THIS ADDENDUM SHALL BECOME A PART OF THE PLANS AND SPECIFICATIONS AND ITS RECEIPT SHALL BE NOTED ON THE BID FORM. (22 pages total)

New Town American Legion
Addendum #01
08/21/2026

Advertisement For Bids**American Legion Restaurant; New Town, ND**

The Project is a restaurant/bar which includes a 4,600 sf addition and interior demolition and remodel of a current 3,700 sf space, for a total of 8,300 sf.

A601

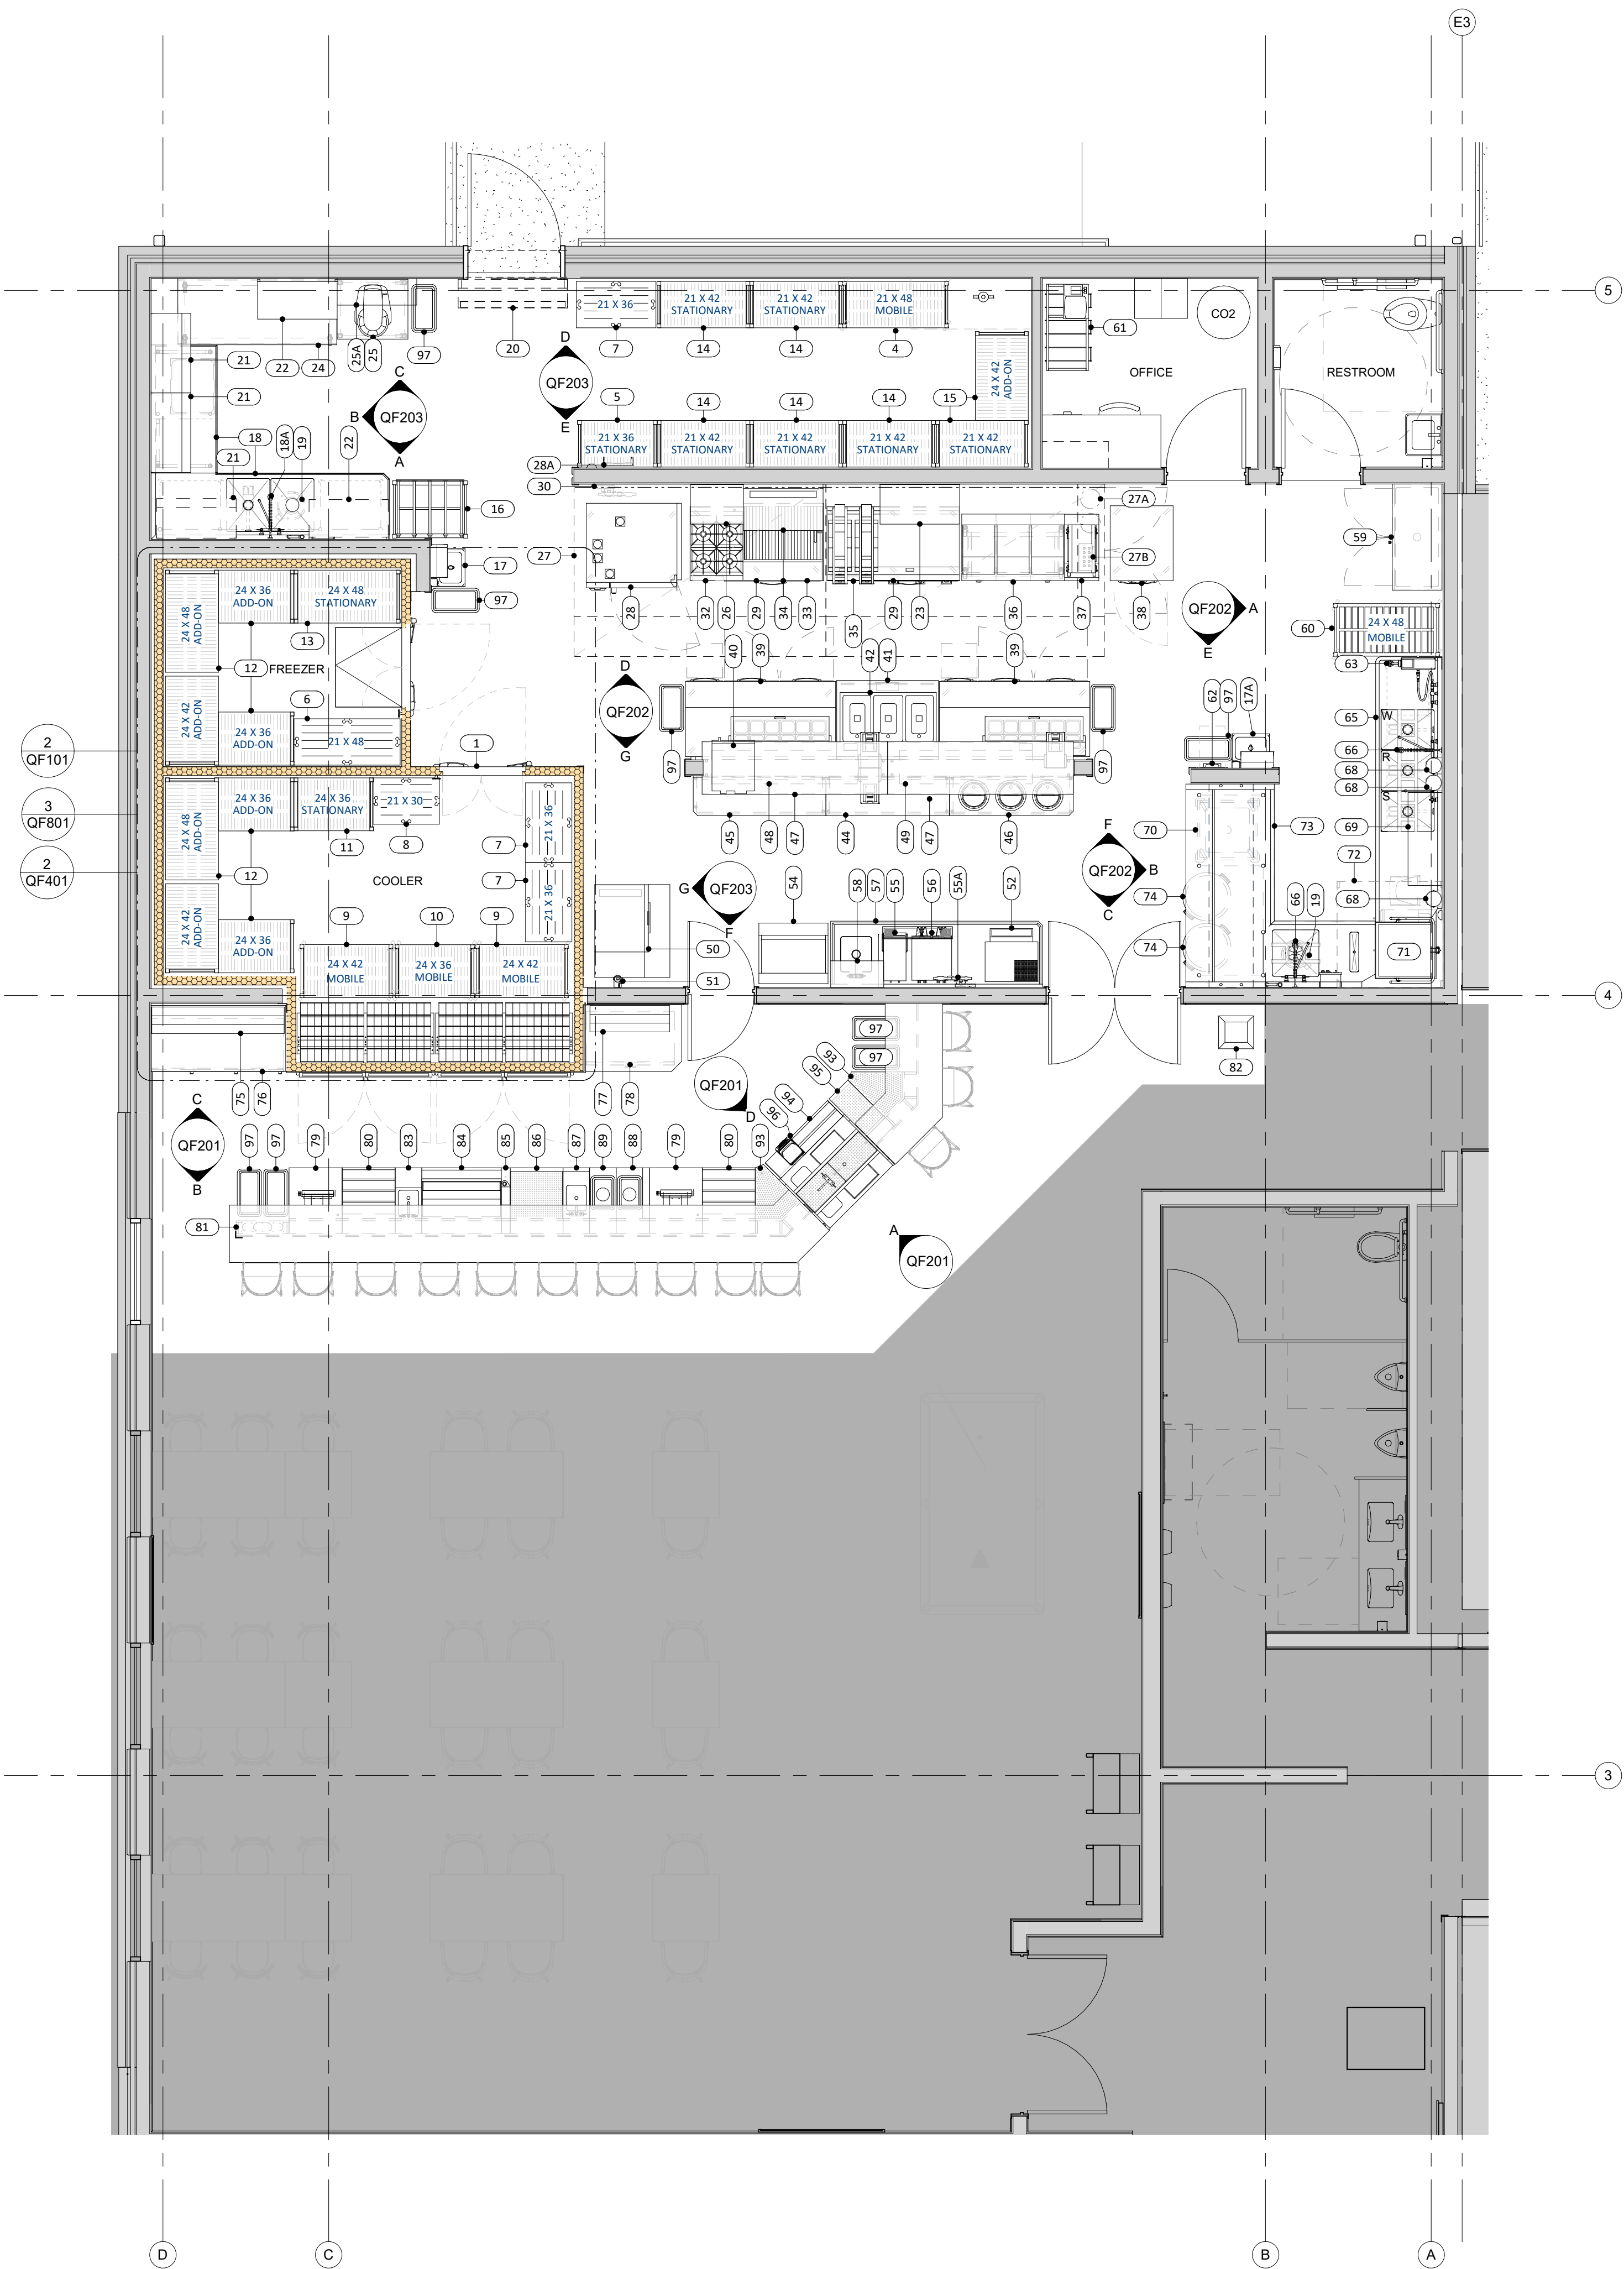
1. G001 – General Notes / Drawing Index
 - a. See updated Drawing Index with S104 removed from the Index.
2. A601 – Door Schedule & Storefront Elevations
 - a. See updated Door Schedule with clouded corrections made.

ENLARGED PLUMBING PLAN - EAST KITCHEN WALL

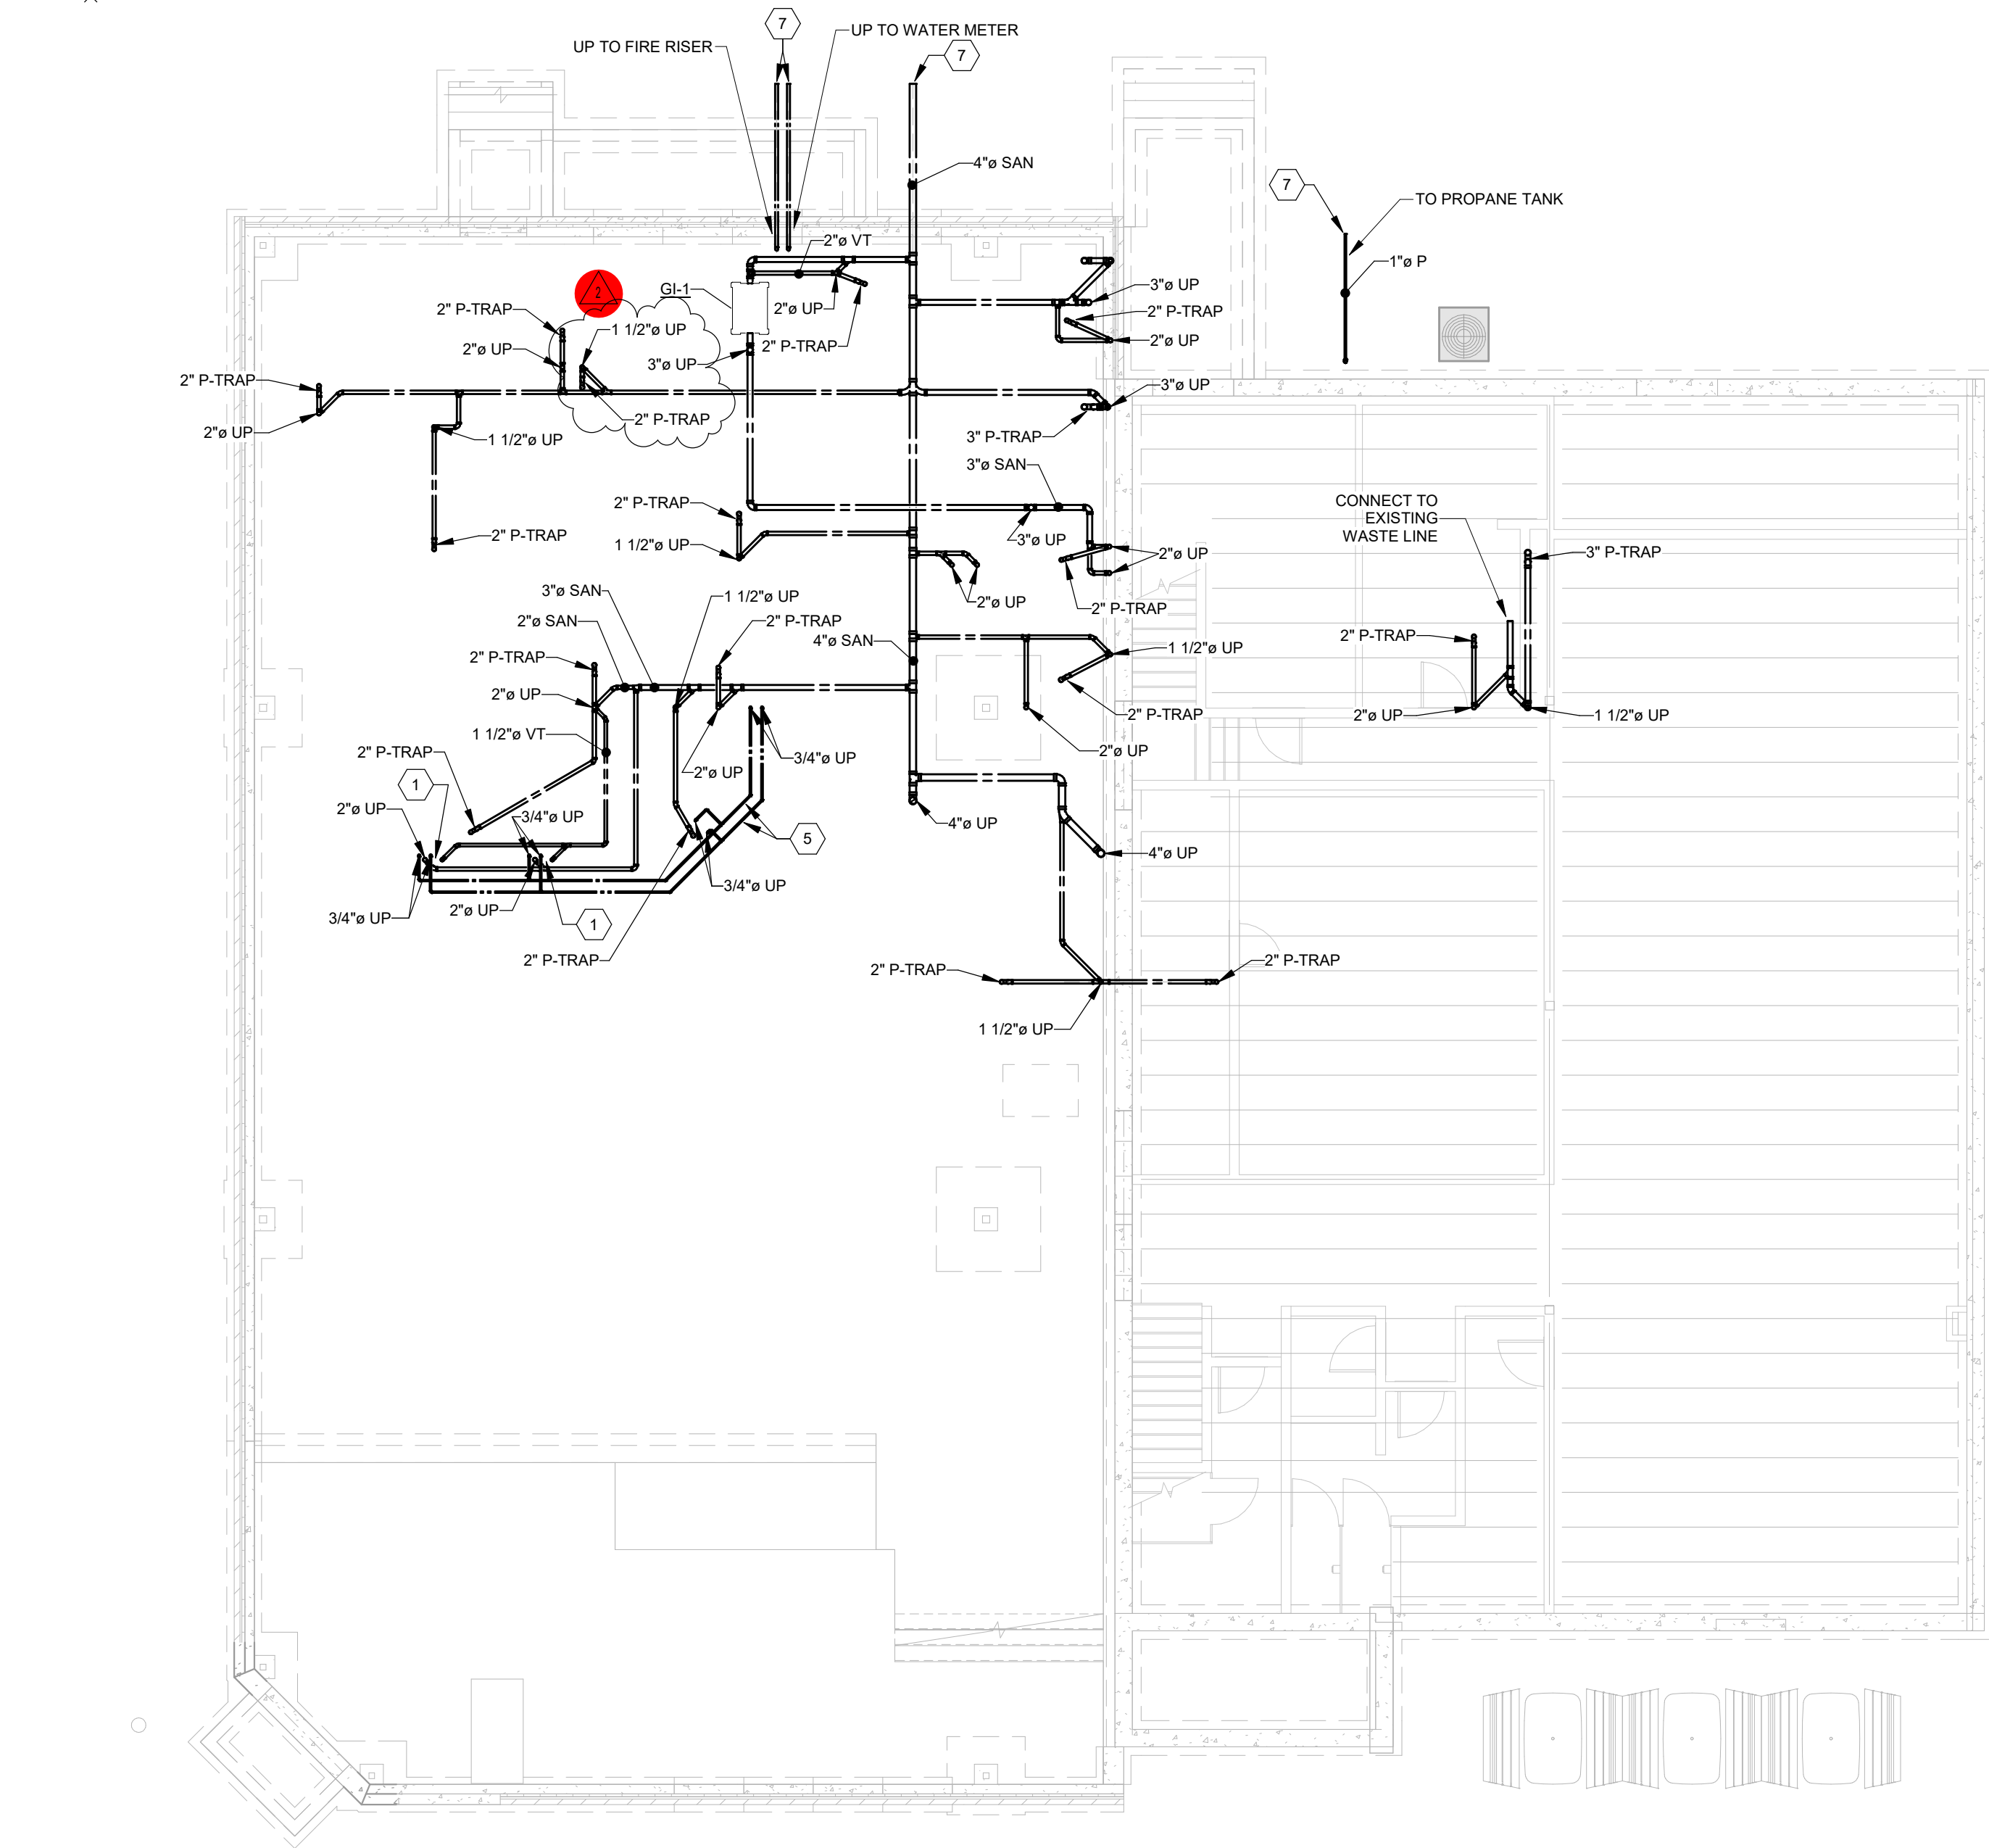
1. M200 – Plumbing Plans
 - a. Floor sink added beneath cook line.
 - b. Domestic water supply to mop sink cabinet drops down north kitchen wall in lieu of east wall.
